# INSPECTION OF MECHANICAL FEATURES

## Helmand Valley
## Development Project

Prepared for Agency for International Development

May 1964

Drawing No. 3

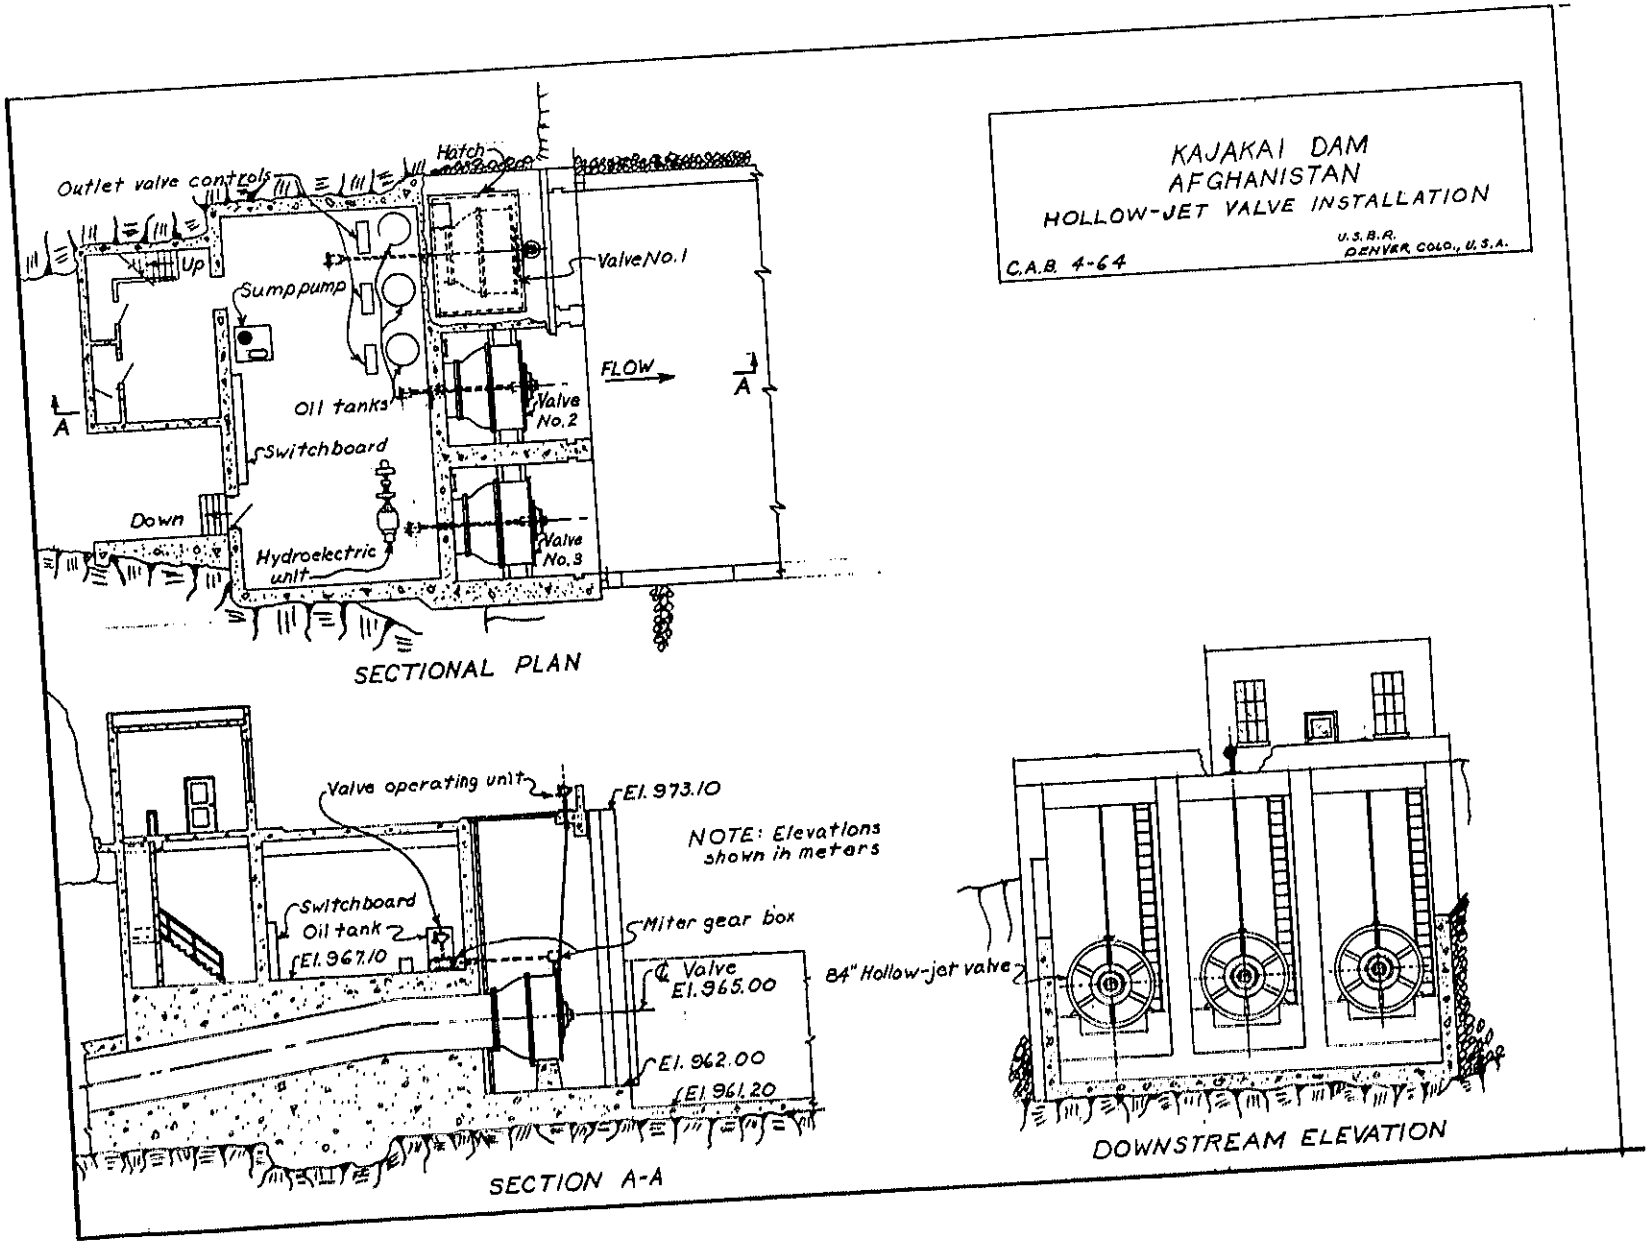
3. The electric control instruments (Figure 7) including the pushbuttons, selector switch, indicating lights and indicator for each hollow-jet valve should be moved from the present control board to a small panel located on the wall adjacent to the hydraulic controls. This will give the operator a more convenient control system. The installation of an ammeter on the control panel for the gear unit motor would aid the operator in the operation of the hollow-jet valves. To give the operator better access to the hollow-jet valve controls, the valve operating unit should be moved into the control house. The shaft could be passed through a packing gland in a sleeve through the wall of the control house. Shaft connections between the hollow-jet valve and valve operating unit could be made with two sets of miter gear as shown on Drawing No. 3.

Figure 12.--Arghandab Dam. The 48-inch Howell-Bunger valves are in the fully open position for inspection. Note that the stainless steel seat at the downstream of the cones is in perfect condition, but the metal upstream from the seal seat is severely cavitated.

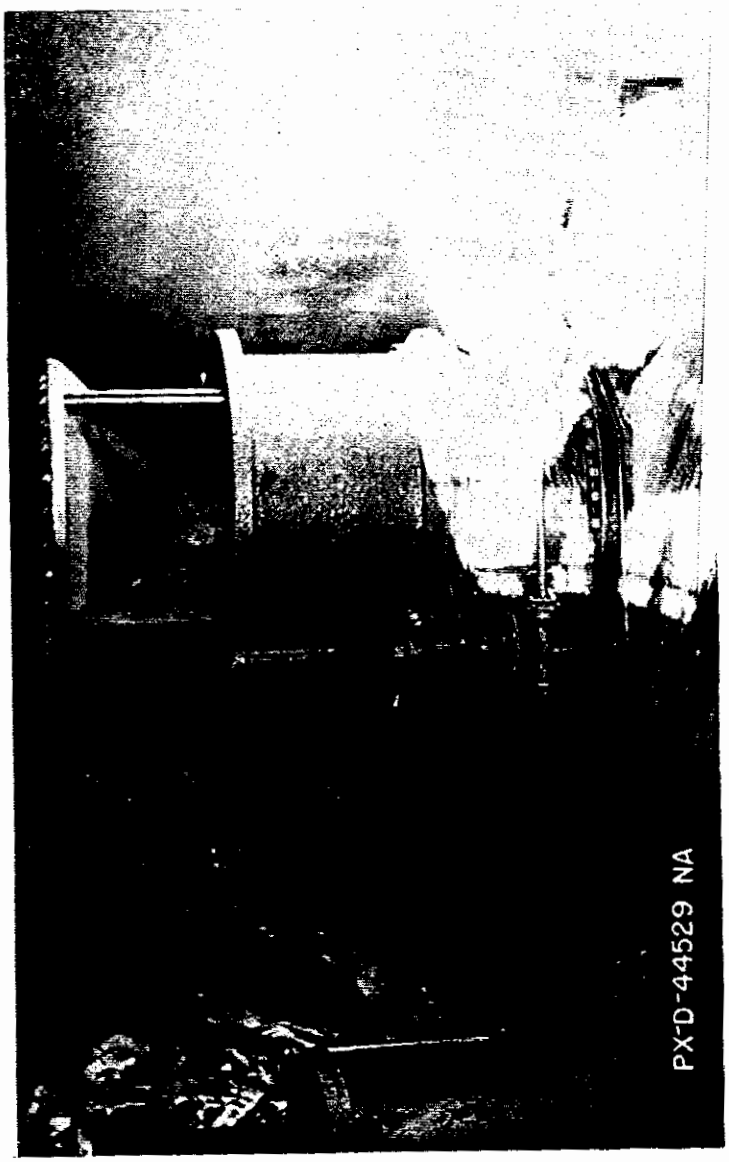
end of the cylindrical sleeves are cavitated around the circumference from the edge of the seal to approximately 4 inches (10 centimeters) upstream. Some of this surface has been repaired by building up with stainless steel weld metal, but is still in serious need of repair. The cones are severely cavitated with pits more then 1/8 inch deep, for an area around the circumference at the discharge end and from edge of the seal to a distance of 10 inches (25 centimeters) upstream (Figure 12).

1. Arrangements should be made to remove the Howell-Bunger valves and repair the cavitated areas to prevent progressively greater damage. The valves are severely damaged and should be removed so that first-class welding and finishing can be done.

Figure 19. --Girishk Powerplant Unit 2. Turbine runner blade shows evidence of severe dragging between the edge of the blade and lower crown ring.

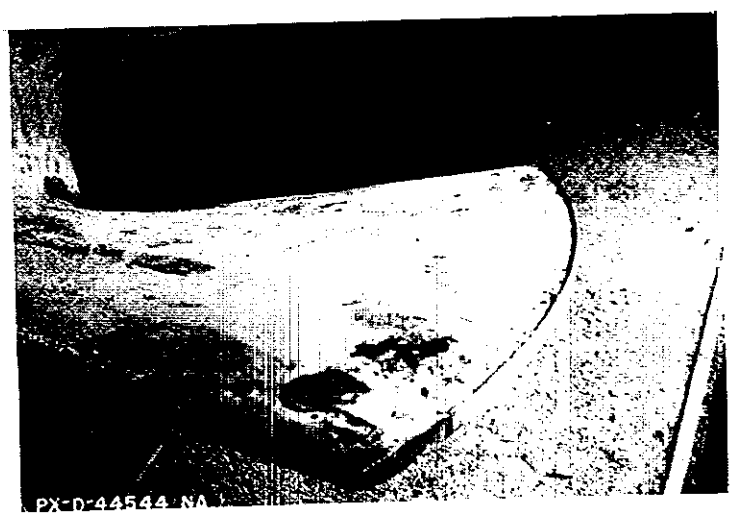
Outside edges of the rotor blades (Figure 19) have worn flat and the edges have curled out beyond the thickness of the blades. The turbine shaft (Figure 20) and turbine shaft bearing were found badly grooved and worn. The lower crown ring was found 0.4 inch (1 centimeter) out of level. The shaft coupling had been shimmed with wedge-shaped shims so that the bolts could be tightened without leaving a gap at the coupling joint. The two shaft flanges do not appear to be parallel. The space between the turbine wicket gates, in the closed position, varied from .002 to .110 inch from top to bottom on some of the gates. Enough water leaked past the wicket gates to prevent the turbine from stopping without heavy application of the brake. The governor shaft that extends below the generator and operates the wicket gates was approximately 1.5 inches out of plumb and a support bracket was found broken. A new bracket has been installed and alinement has been corrected. The turbine is designed for a wicket gate opening of 10.5 inches (26.7 centimeters). The maximum opening that can be obtained with the present linkage on the governor shaft is 9.125 inches (23.2 centimeters).

Drawing No. 6

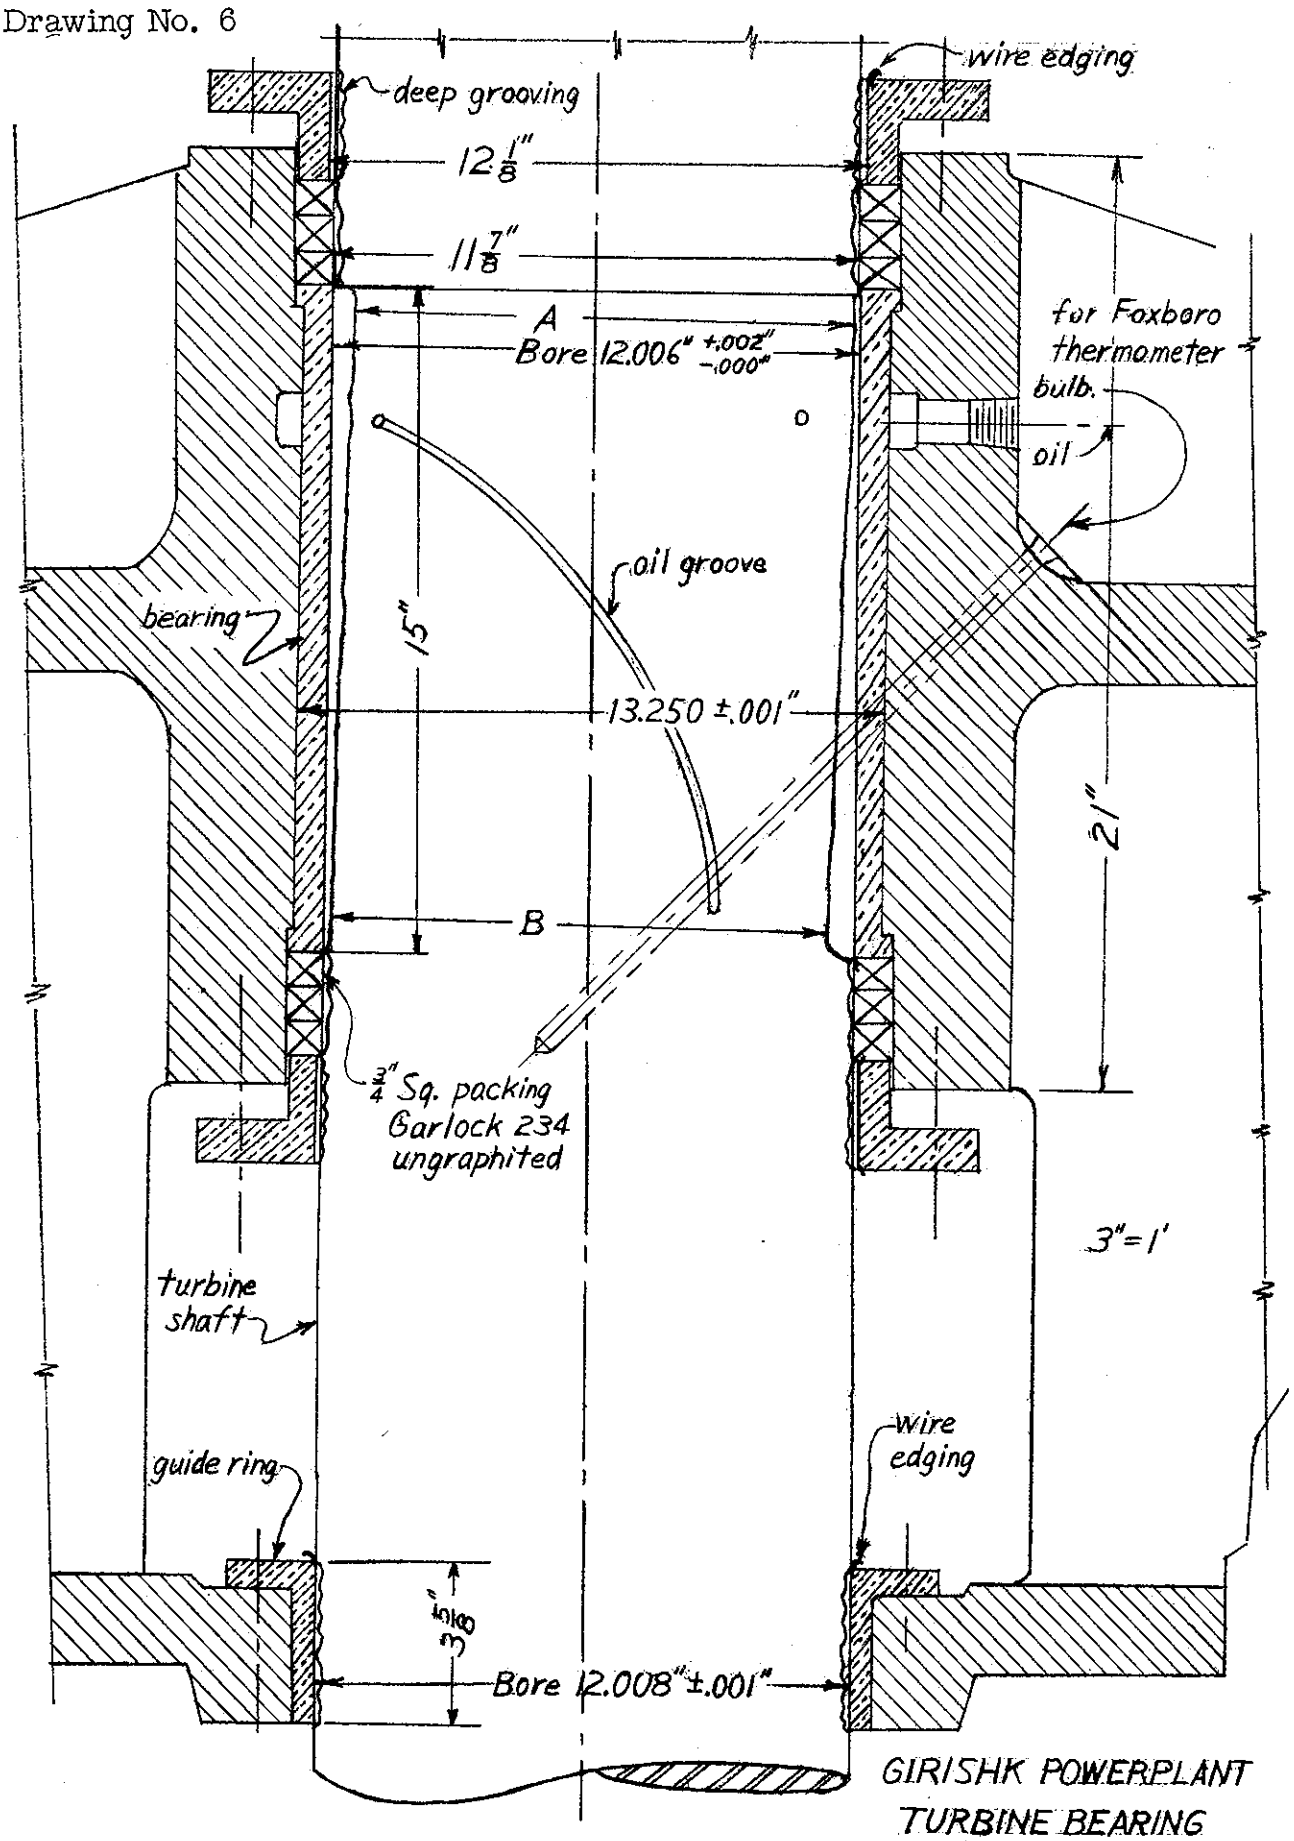
Shimming in sizes up to 3/8 inch was found under the legs of the turbine bearing bracket (Figure 22) and the holes for the bolts that fasten the bearing bracket to the turbine were enlarged from 1 9/16 inch, as shown on the drawing, to 2 1/8 inch as shown in Figure 23. The space between the 1 1/2 inch bolt and the hole had been filled with lead.

2. The upper packing gland and lower guide bushing showed evidence of severe wear. The inside surfaces were grooved and wire edging curled over the flange as shown on Drawing No. 6. This was caused from extreme eccentric pressure of the turbine shaft.

GOVERNOR SHAFT LINKAGE

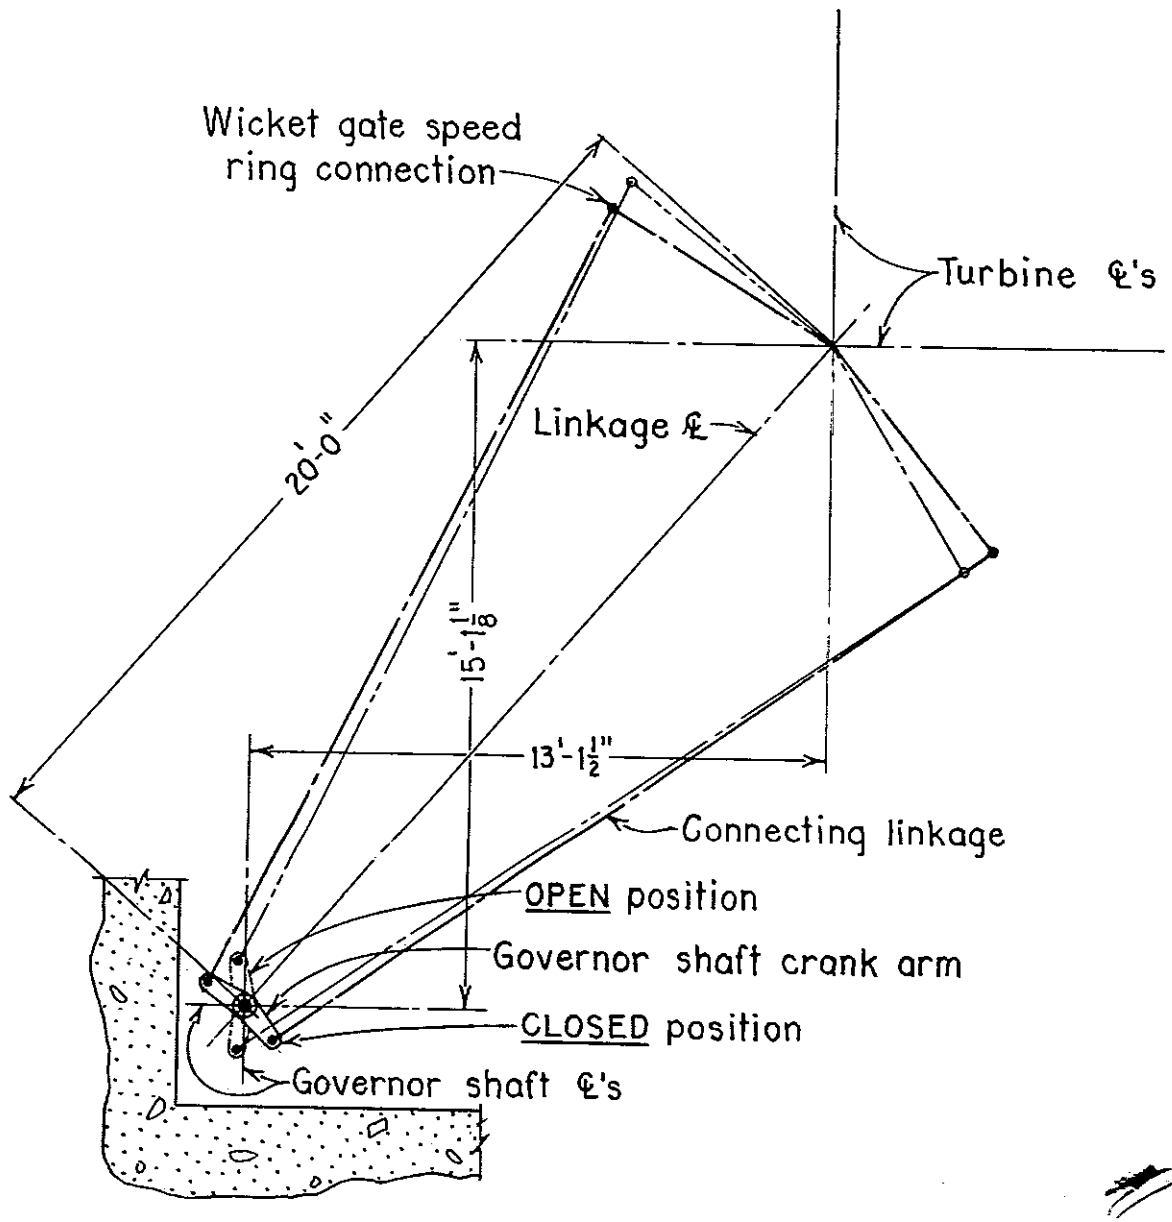
With the governor in the maximum opened position, the wicket gates opened a maximum of 8 3/4 inches instead of the intended design opening of 10 1/2 inches. (Leffel Drawing 48642)

8. The governor shaft and wicket gate linkage does not appear to be set properly to obtain the design opening intended for the wicket gates. The crank arm on the governor shaft, that actuates the long connecting linkage to the wicket gate shift ring, is approximately perpendicular to the linkage centerline (Drawing No. 7). When the wicket gates are opened, the governor shaft crank arm is turned to the extreme right as shown by the dotted line - (Drawing No. 7). This condition, along with loose fitting linkage connection bushings, account for the wicket gates not opening the full 10 1/2 inches. Maximum wicket gate opening is obtainable when the governor shaft crank arm is set so that it is perpendicular to the linkage centerline when the wicket gates are midpoint of opening.

Figure 31. --Boghra Canal Wasteway. The notch-type clutch is used to change from manual to automatic control of the wasteway gates.

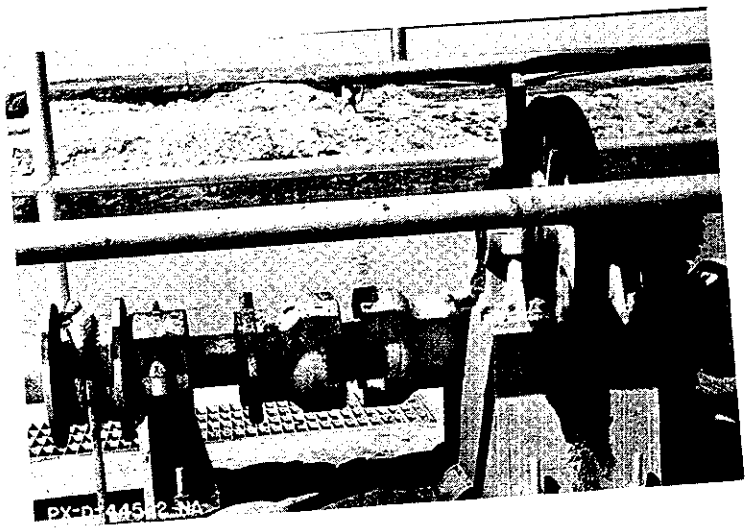
not go down. After prying the weight loose from the guides and dislodging the rope drum shaft from its bearings with a bar, the automatic mechanism began to work, but very sluggishly. The clutch (Figure 31) on the end of the rope drum shaft which should slide freely by hand could not be shifted even by forcing it with a bar. In examining the shaft it was found that lack of greasing and accumulation of dirt, grit and hardened grease had bound the bearings to the shaft so tight that it required tremendous force to turn it.

1. Remove all bearing covers from the wire rope drum shafts, clean bearings and shaft bearing surface with kerosene or some suitable solvent that will remove the dried grease and dirt. Smooth bearing surfaces, if necessary, and reassemble.

2. Check to see that all grease holes in bearings are open, replace missing grease fittings, and grease all shaft bearings once a month during irrigation season.

Figure 33. --Boghra Canal Wasteway. Wire rope drum shows type of anchorage and rope winding over loose end.

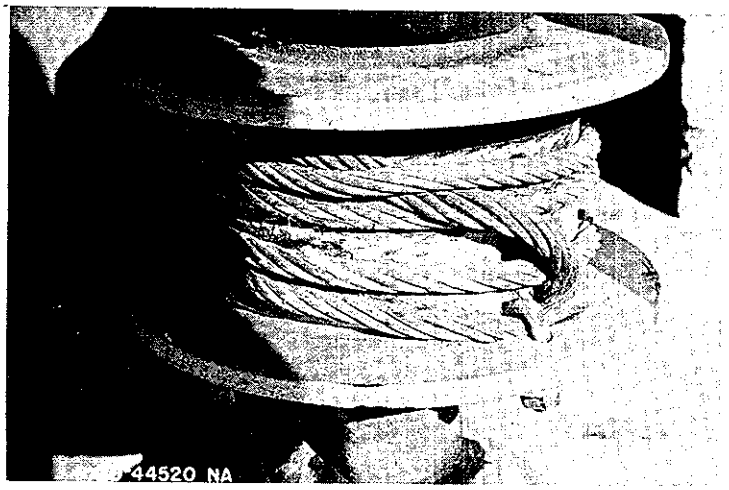
It was reported that the Main Canal tainter gates vibrated violently at certain openings. An examination of the gates disclosed that one hoist rope (Figure 32) was completely rusted through, others badly rusted and frayed, rope clamps were loose and some clamp nuts missing, shaft bearings were dry, and grease fittings were missing. The hoist rope anchors (Figure 33) on the drums are arranged so that the loose end of the rope lies across the bottom of the drum and the rope winds over it at random. In some cases the rope has been purposely wound over the loose end to prevent it from slipping. In any case, these conditions are damaging to the ropes, and will cause unequal tension, which is likely to increase the tendency to vibrate. Grease that has been used on open gears of the rope hoist has combined with sand and hardened, so that it becomes more harmful to gears than no grease at all.

2. Replace all ropes on this structure with stainless steel wire ropes.

Figure 35. --Canal checkgates. Water flowing through a partially opened top-seal tainter gate which has a corrugated skinplate.

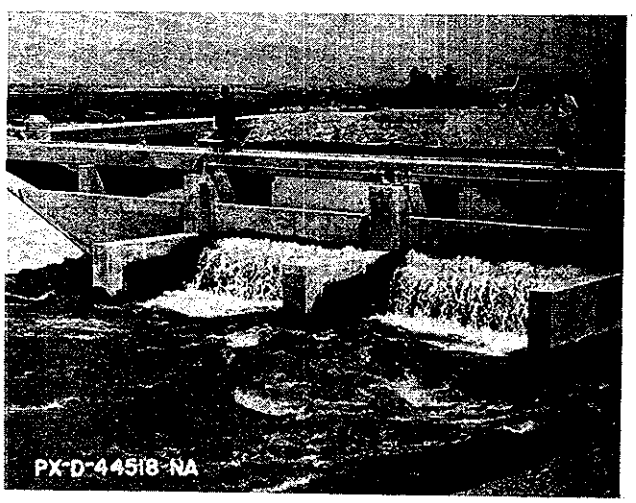
Other similar small structures, such as canal checks, branch canal outlets, and wasteways were examined on the canal system. Many of the small tainter gates (Figure 35) in check structures were top-seal types with corrugated galvanized skinplate. When these gates operate at any intermediate opening, extensive leakage occurs at the top seal because the seal is tight only in the closed position. The amount of leakage is of no consequence, but the continuous flow of water over the back side of the gate is causing considerable deterioration of paint and corrosion of the galvanized skinplates. Many of the hoisting mechanisms have been damaged by heavy traffic passing on narrow bridges over the structures. Small parts of hoisting mechanisms such as nuts, bolts, clamps, and grease fittings are missing.
